SUPPLEMENTAL RESPONSE TO REQUEST FOR ADDITIONAL INFORMATION

APR1400 Design Certification

Docket No. 52-046

RAI No.: 274-8277
SRP Section: 7.1 - Instrumentation and Controls
Application Section: 7.1, 7.3, and 10.2
Date of RAI Issue: 10/27/2015

Figure 7.2-4 CEA Position Signal Flow for CPCS

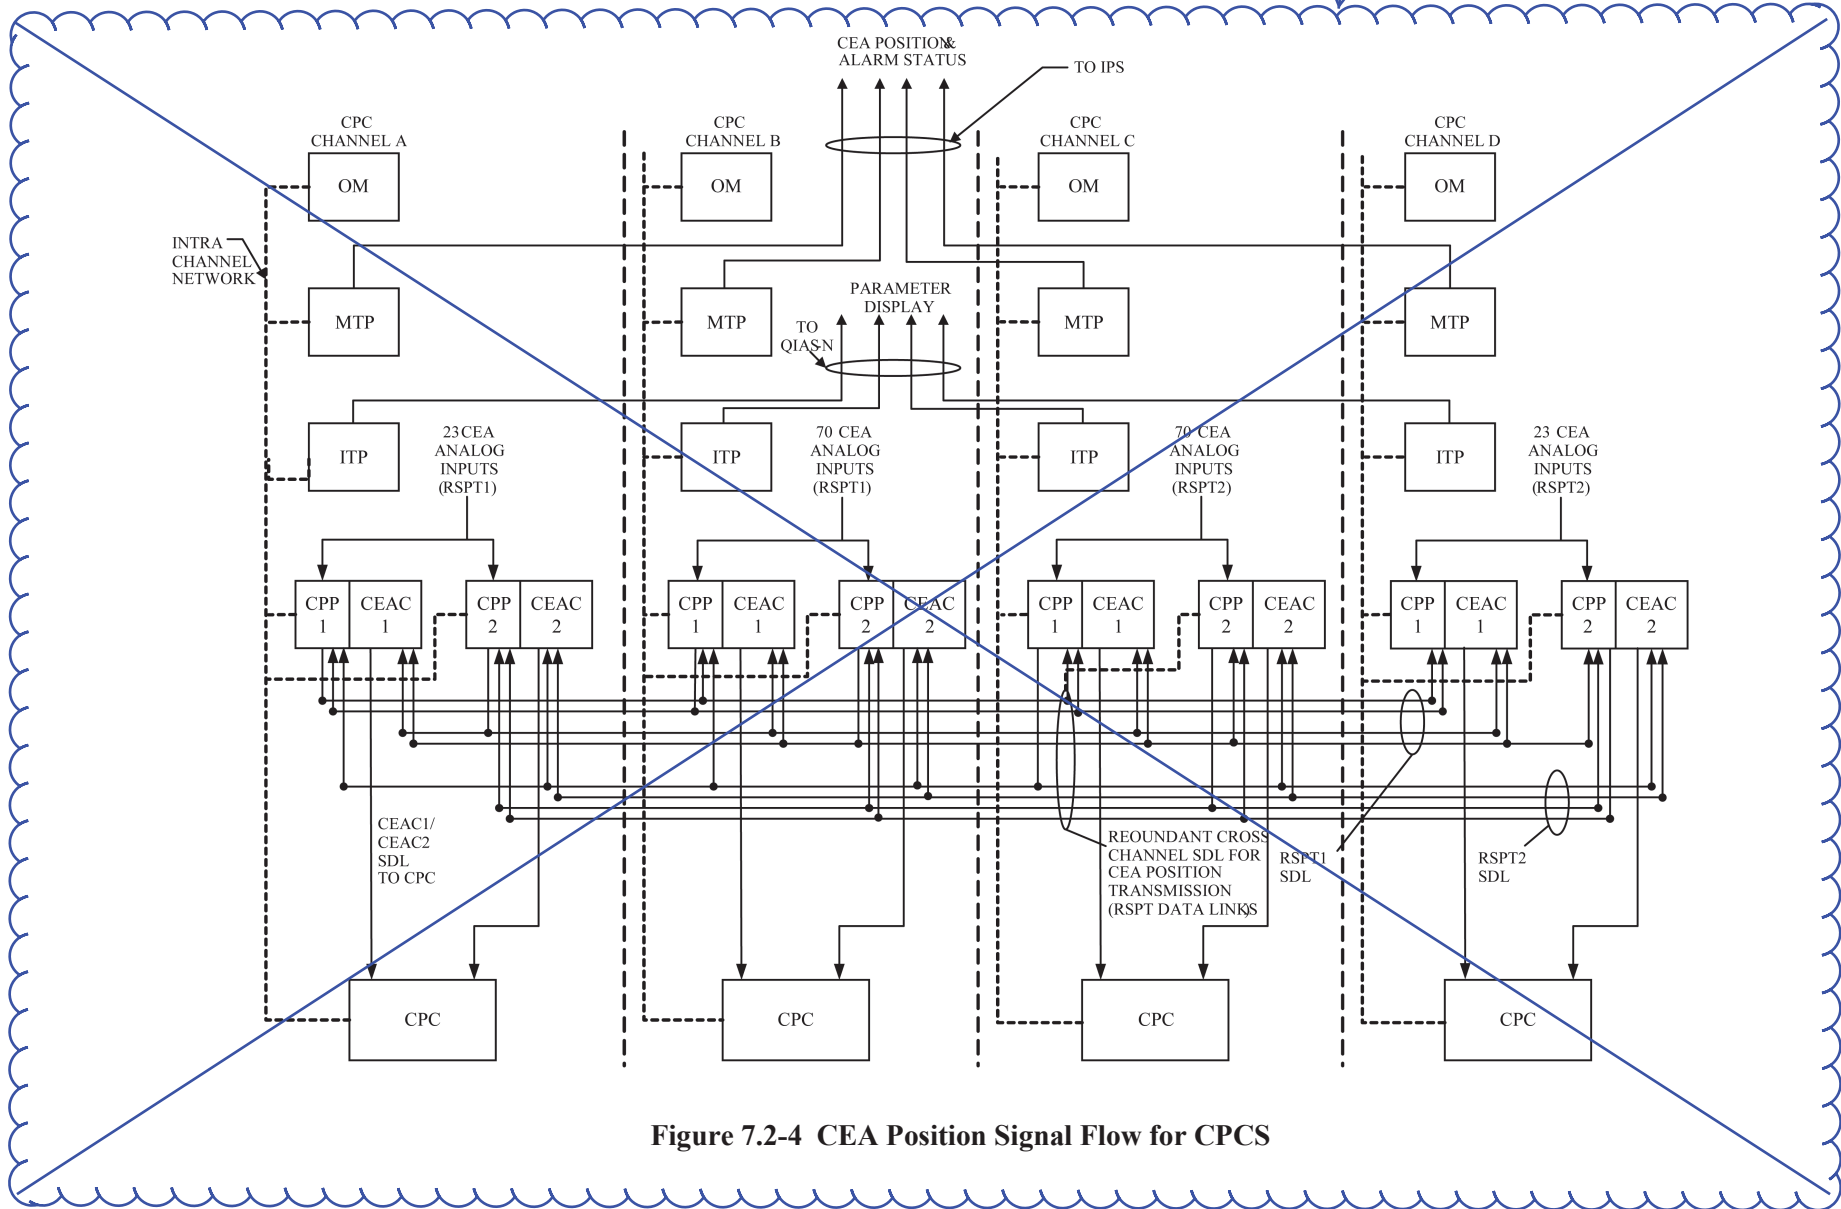
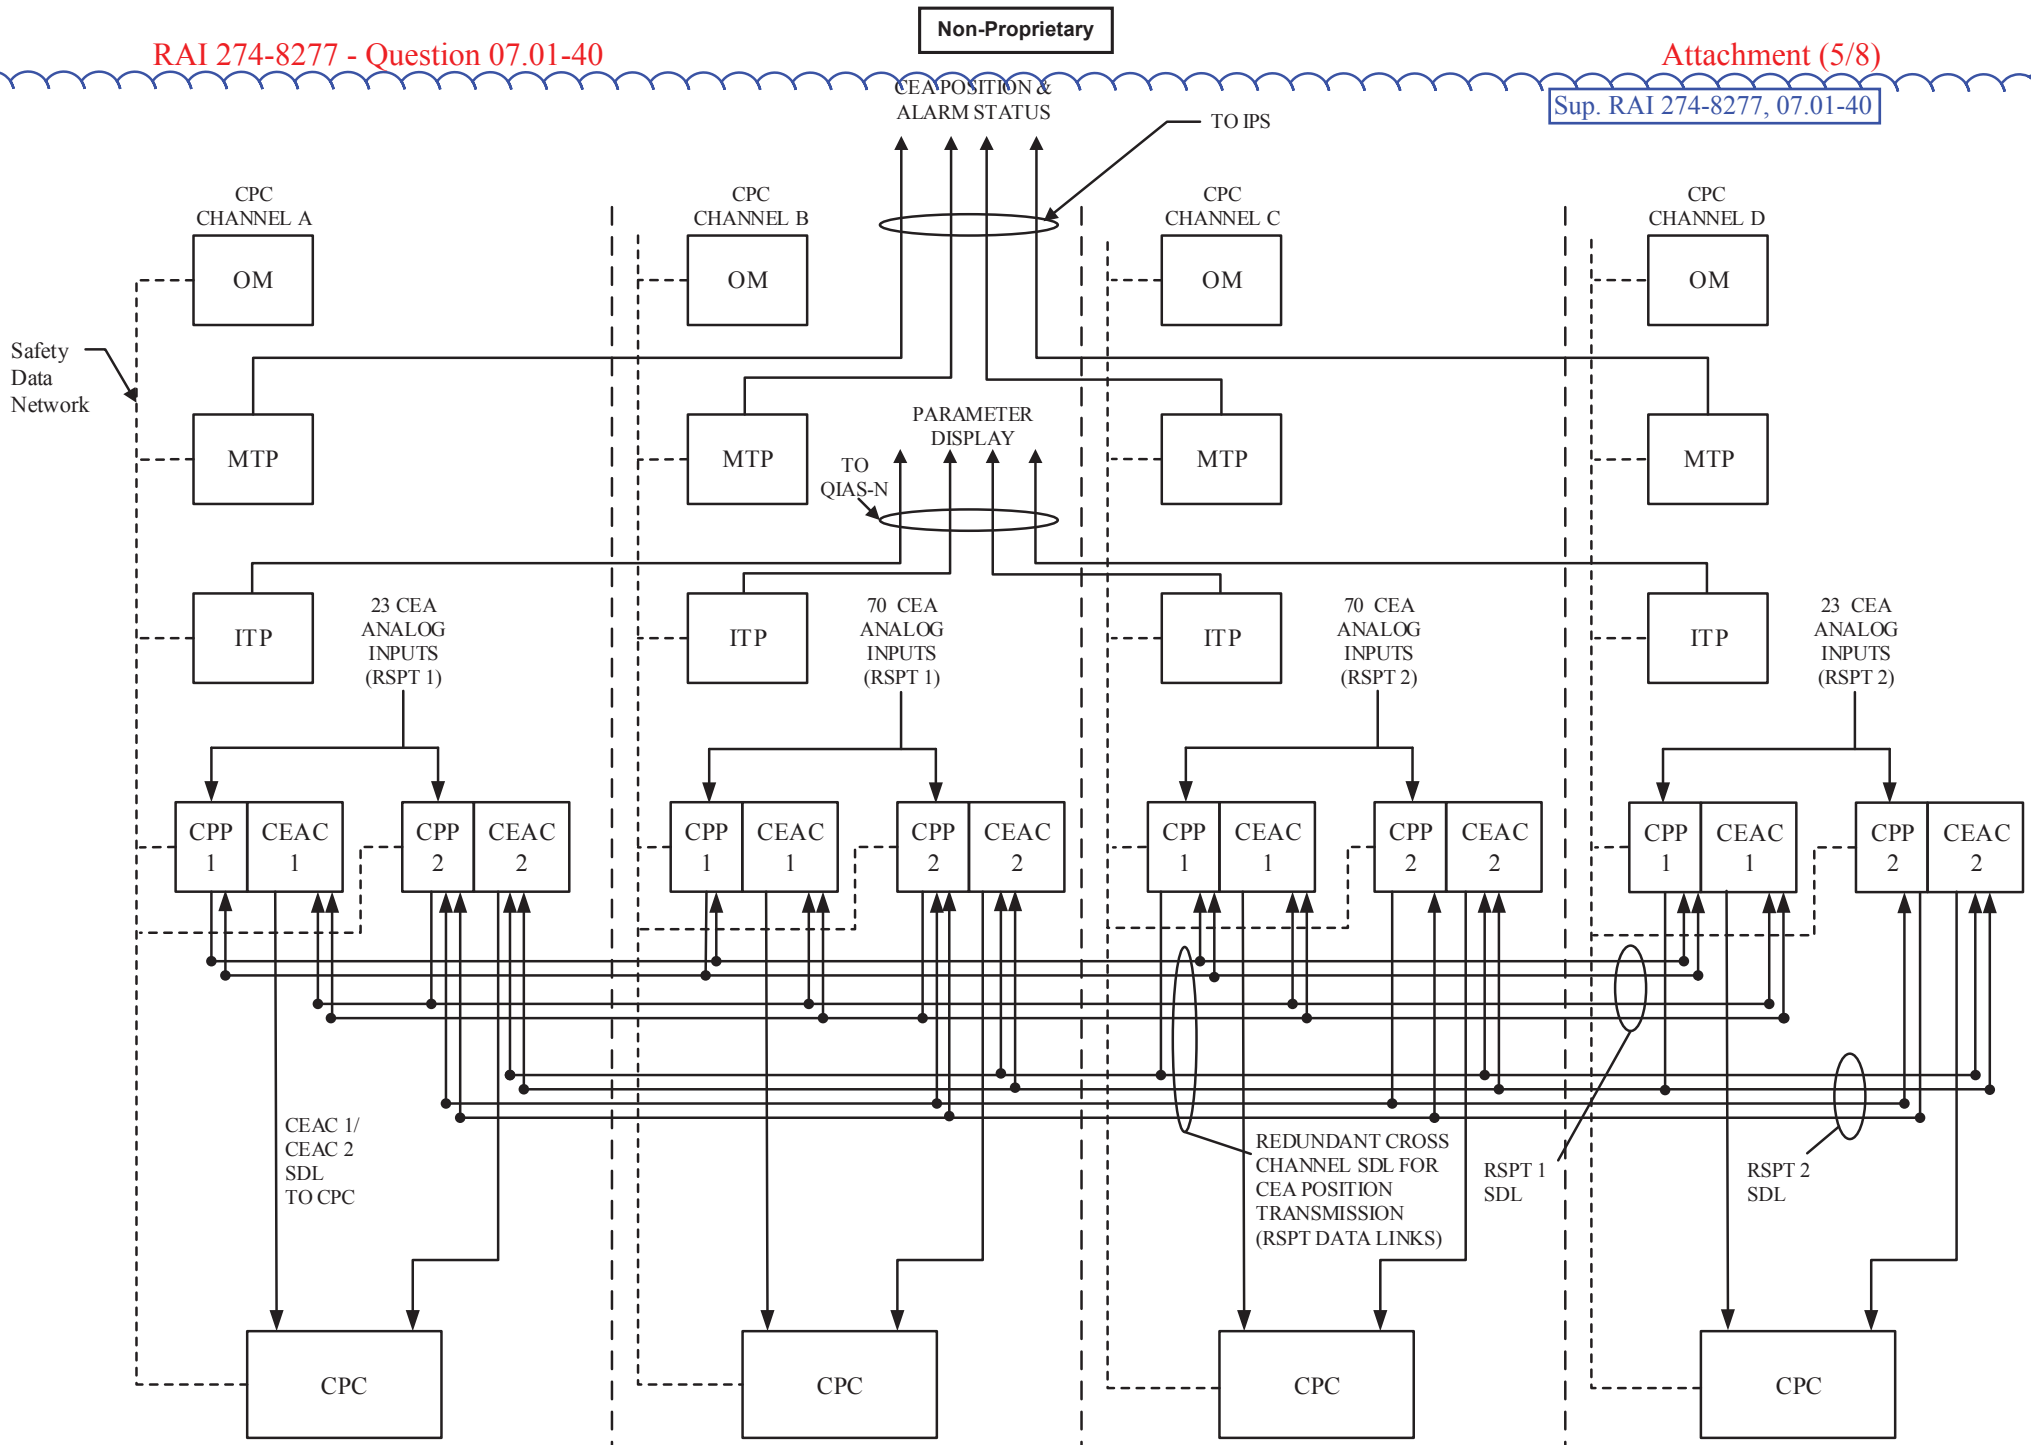
In addition, DCD Tier 2, Figure 7.2-4, "CEA Position Signal Flow for CPCS," will be modified because it was missing a CPP output signal from the Channel D CPP1 module.

The figure will be replaced with the next page.
